RE: New Gath Pool depth analysis

project name & number: Gath Pool Improvements
BH+A Project No. 3457

subject: Lap Pool Depth Study

LAP POOL DEPTH CURRENT DESIGN

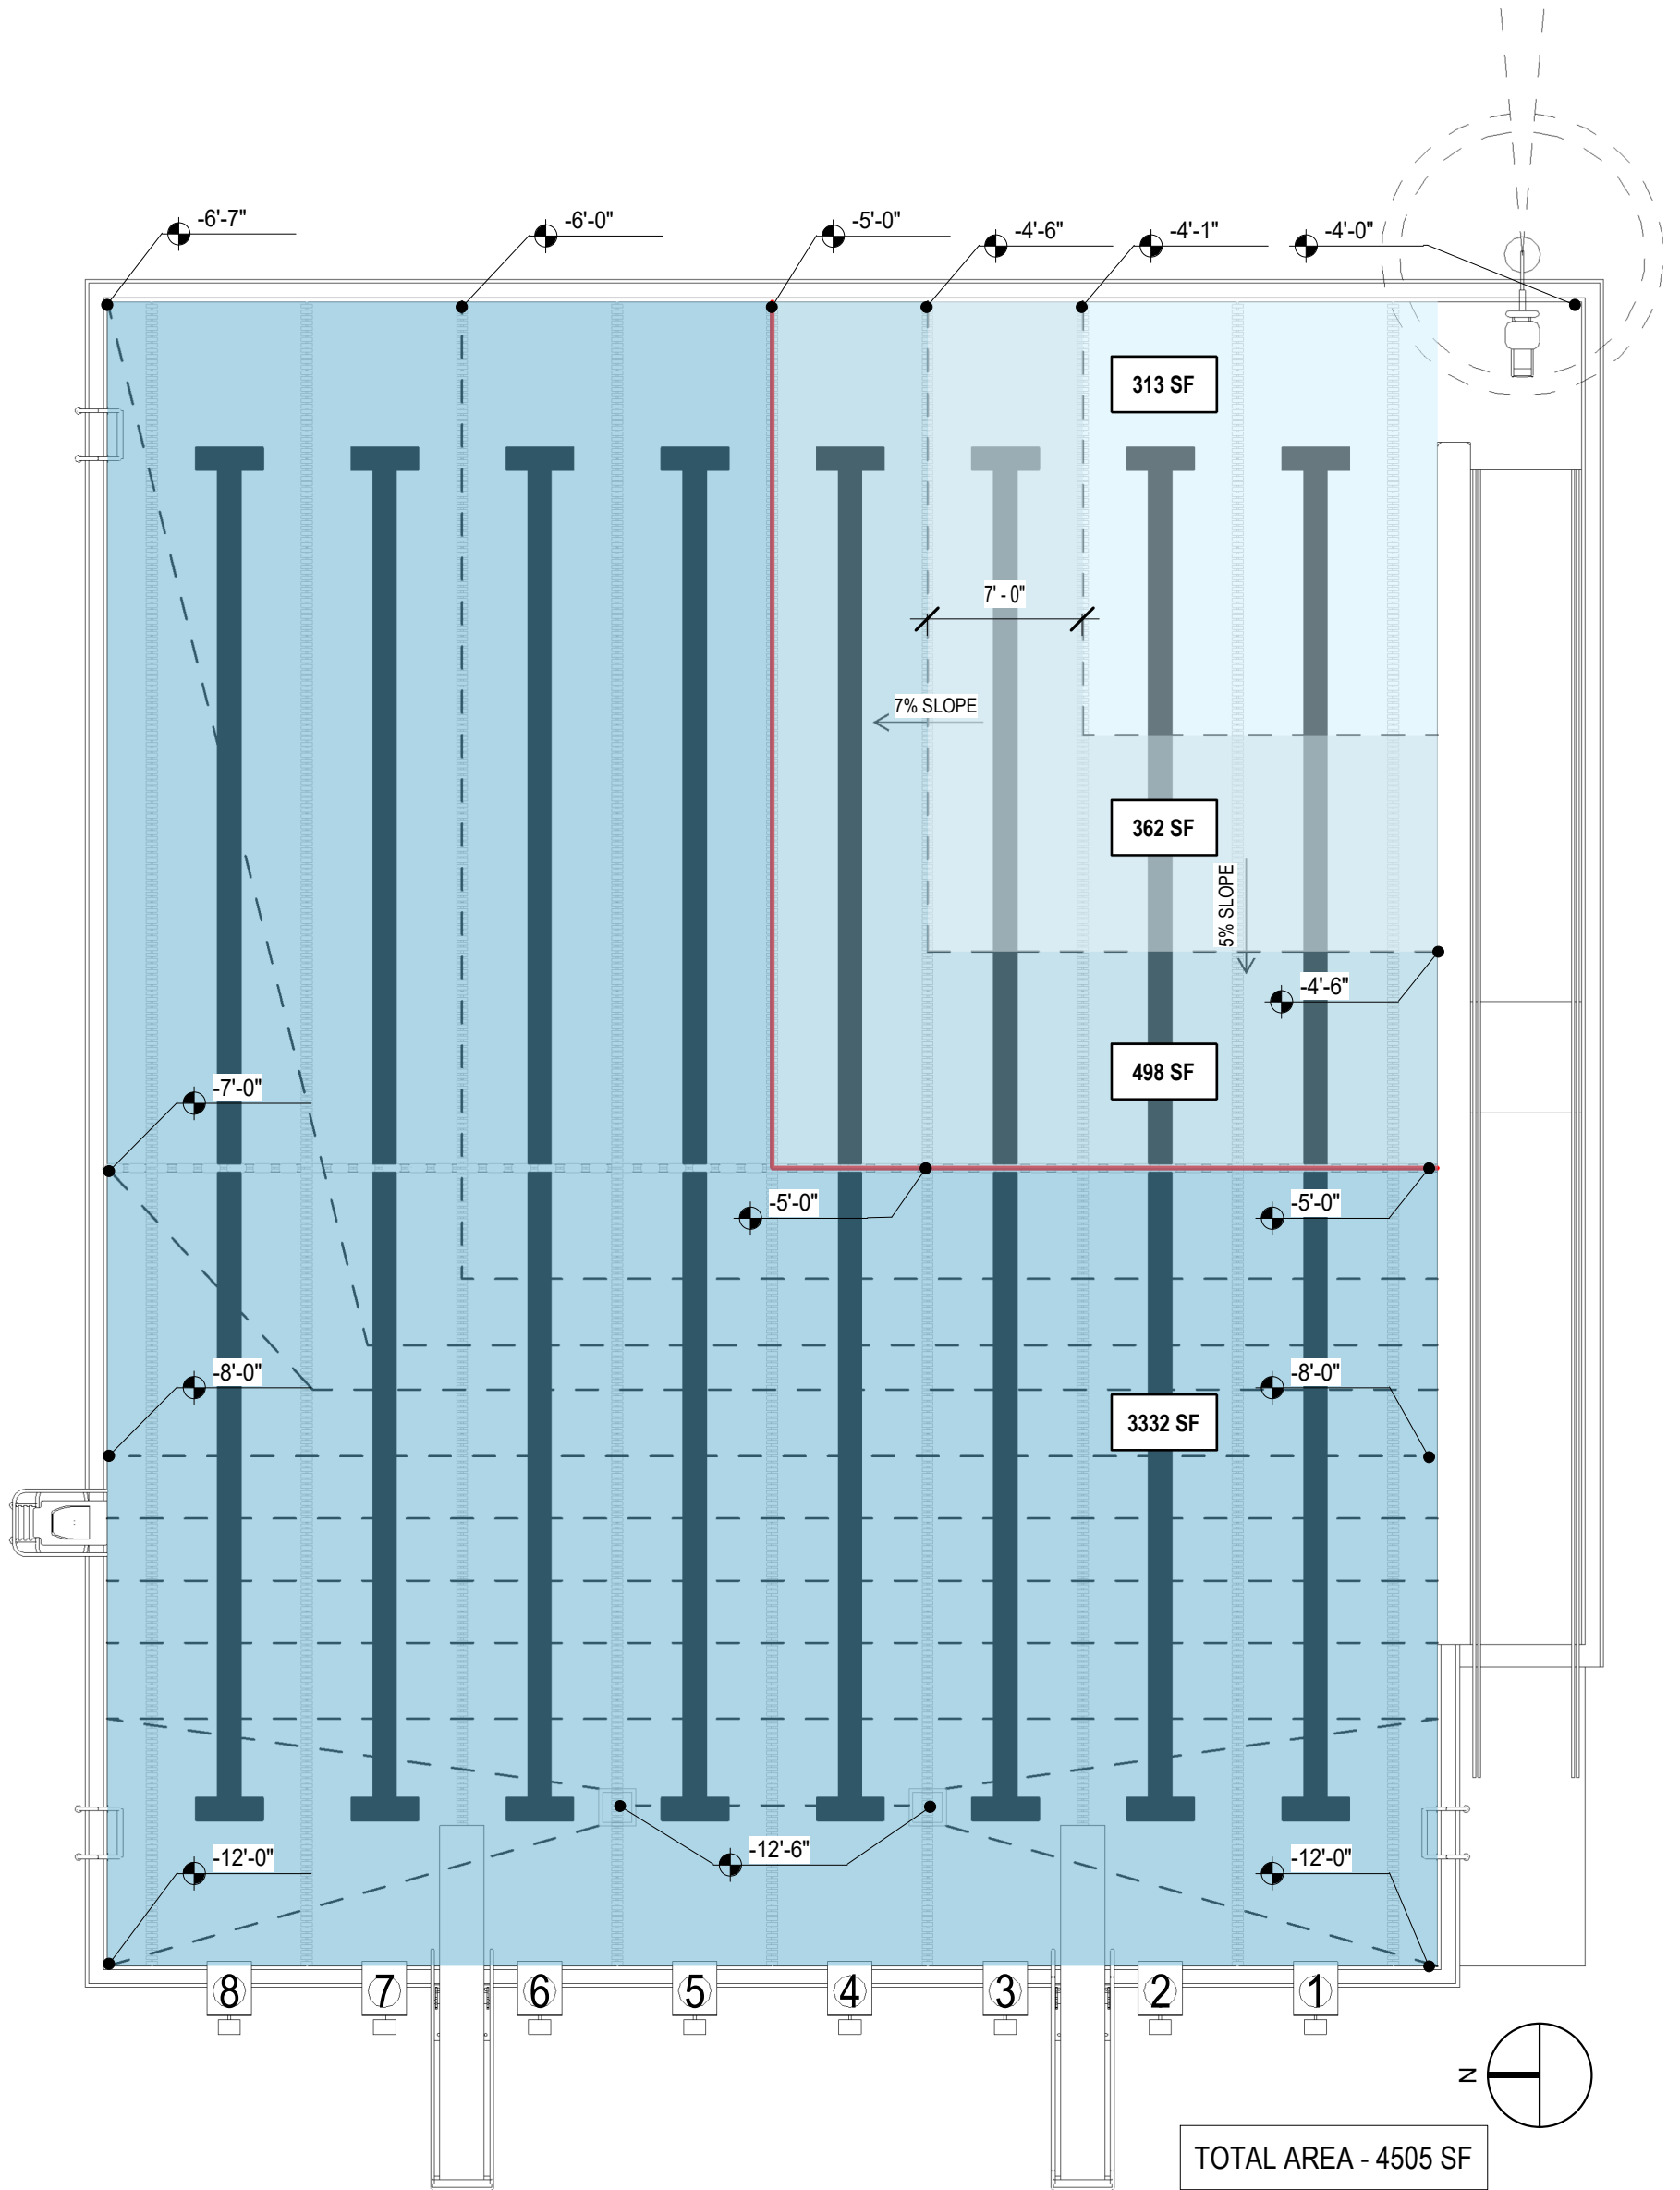
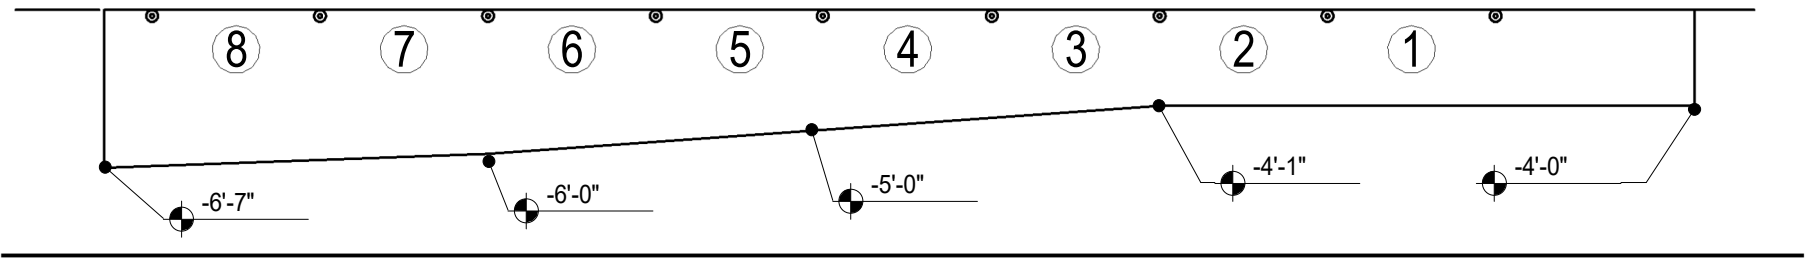
- The shallow wall along the entire length of the pool is 4ft.
- The first ten feet of pool floor slopes at 1%. This area shown shaded is 600 SF.
- The remainder of the non-swimming area slopes at 2%. This area is shown with a diagonal cross hatch. The area is 1,745 SF.
- From the 5ft. depth, the pool slopes to 12 feet.
- The bottom of the pool has a continuous 12 ft. depth around the perimeter, the main drains are set at 12"-6" inches to ensure full drain down of the pool.
- The pool bottom and lane markers are uniform in all 8 lanes.
